### PLANNING BOARD

To: Brookline Board of Appeals  
From: Brookline Planning Board  
Date: March 3, 2016  
Subject: Construct a partial fourth story on roof of a three story building and a roof deck  
Location: 1616 Beacon Street

Atlas Sheet: 21	Case #: 2015-0053
Block: 92	Zoning: G-1.75 (WS)
Lot: 2	Lot Area (sq. ft.): 4,291

ROOF PLAN

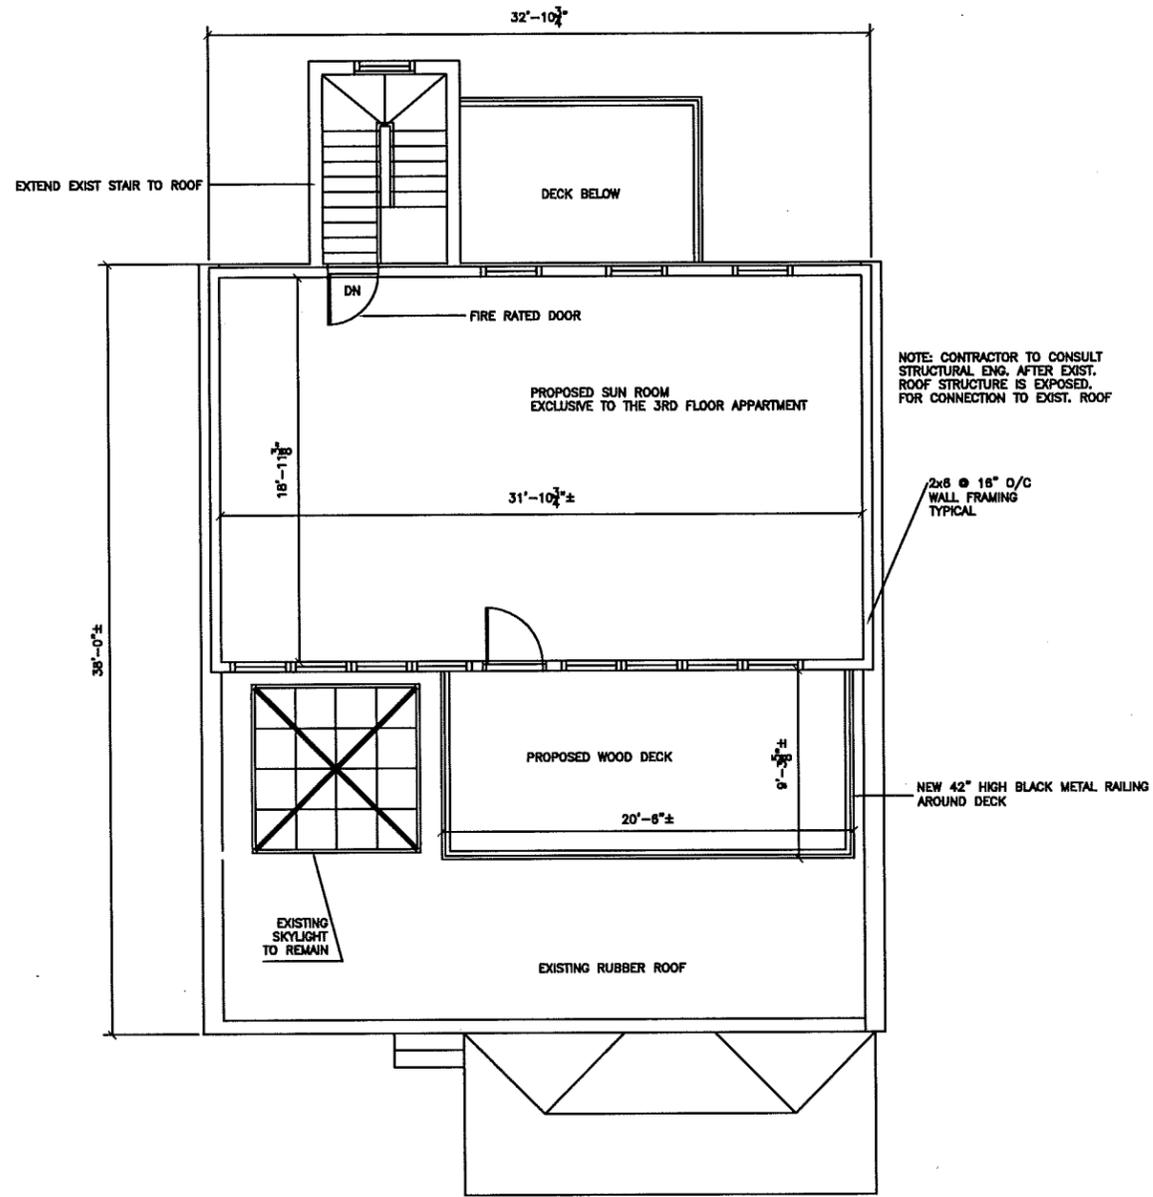
The Planning Board does not object to this proposal to add a partial fourth floor to this building. The applicant has agreed with the suggestion of the Planning Board to remove a second stair head house on the roof that is visible from Beacon Street. After viewing renderings of the addition showing alternate façade materials of stucco and clapboard, the Planning Board left the choice of material to the applicant and also stated that it would have no objection to the replacement of the head house with a skylight. Additionally, the Planning Board supported the addition of a small roof deck with a metal railing as an amenity to the top floor resident.

1. Prior to the issuance of a building permit, the applicant shall submit final site plan, floor plans, and elevations showing the elimination of the forward head house, subject to review and approval by the Assistant Director for Regulatory Planning.
2. Prior to the issuance of a building permit, the applicant shall submit a final landscaping plan, subject to review and approval by the Assistant Director for Regulatory Planning.
3. Prior to the issuance of a building permit, the applicant shall submit to the Building Commissioner for review and approval for conformance to the Board of Appeals decision: 1) a final site plan stamped and signed by a registered engineer or land surveyor; 2) final floor plans and elevations stamped and signed by a registered architect; and 3) evidence that the Board of Appeals decision has been recorded at the Registry of Deeds.
